# Staff Report

Re: PLNAPP2017-00954 Appeal of an administrative decision to issue a building permit for additions to the house at 835 E 18th Avenue

## Appeal of Administrative Decision

**Site / Grading Plan 11/2017**

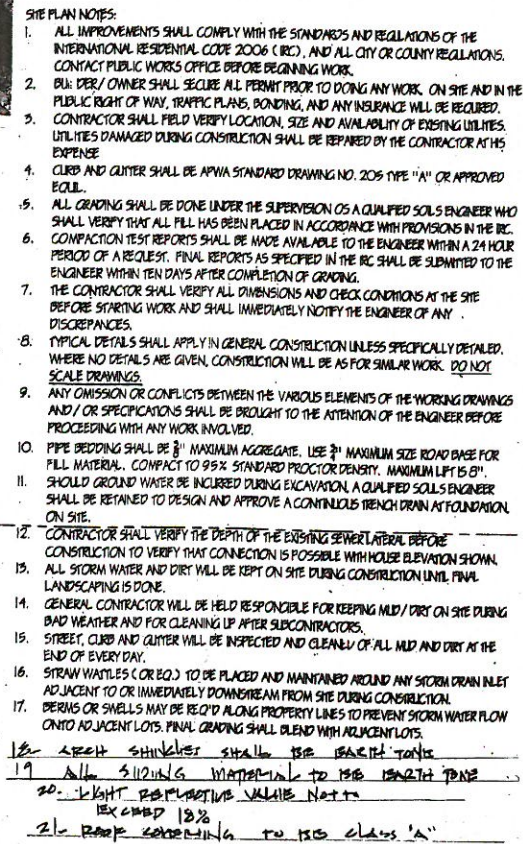
AVERAGE SET BACK	
MINIBEST	20.5
HOME #2	20.5
" #3	16
" #4	25
" #5	41
HOME #6	25
TOTAL	124.5
AVERAGE	24.9

- 1) Site Plan – Grading Plan :
  - a) Modification of the Average Setback Table to include the address and setback information of each property as determined by Von R. Hill – Professional Land Surveyor, stamped and dated November 28, 2016.

**As-Built Site Plan 12/14/2017**

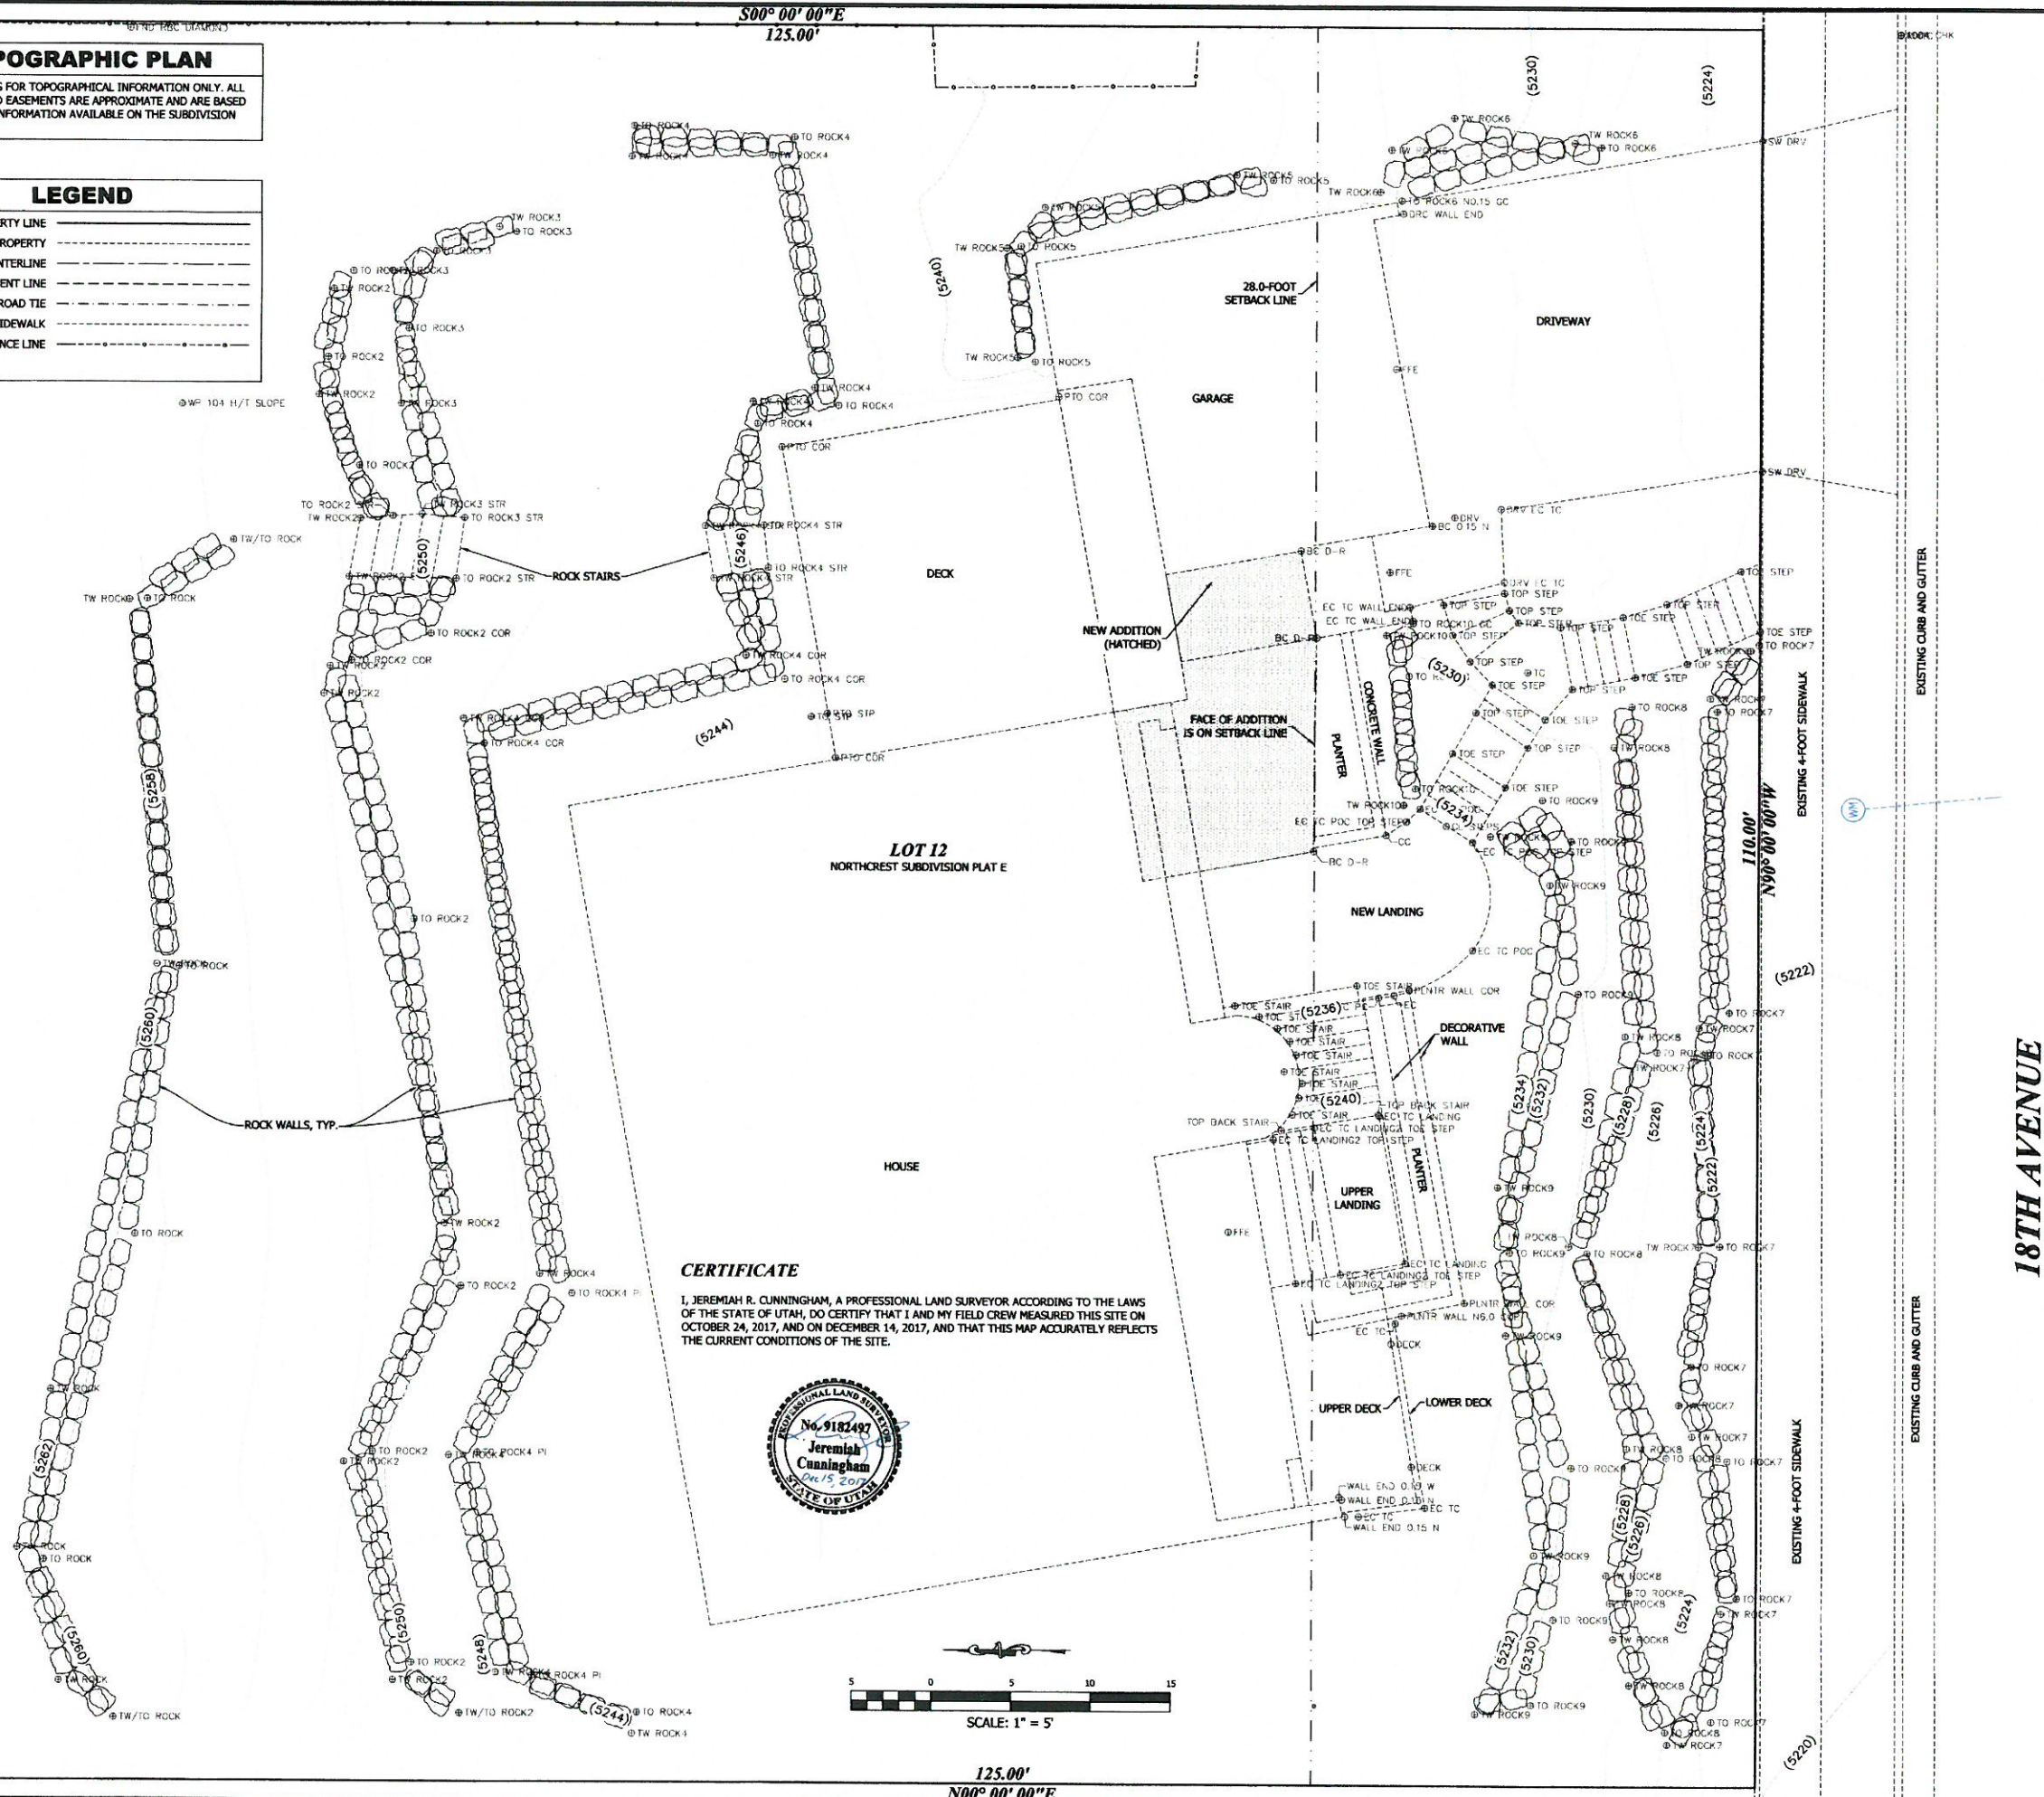
On January 5, 2018, our field crew visited this site to verify compliance of new construction regarding the city-approved, 28.0-foot front setback. We were informed of changes in the structure since a prior visit on December 15, 2017. We compared our observations and measurements to the following documents:

- A. The approved site plan (revised 10/30/2017)
- B. The bay window amendments (revised 11/14/2017)
- C. A building inspection report outlining the approved obstructions within the setback (Inspection Date and Time: "2017-12-20 / 13:42:30")
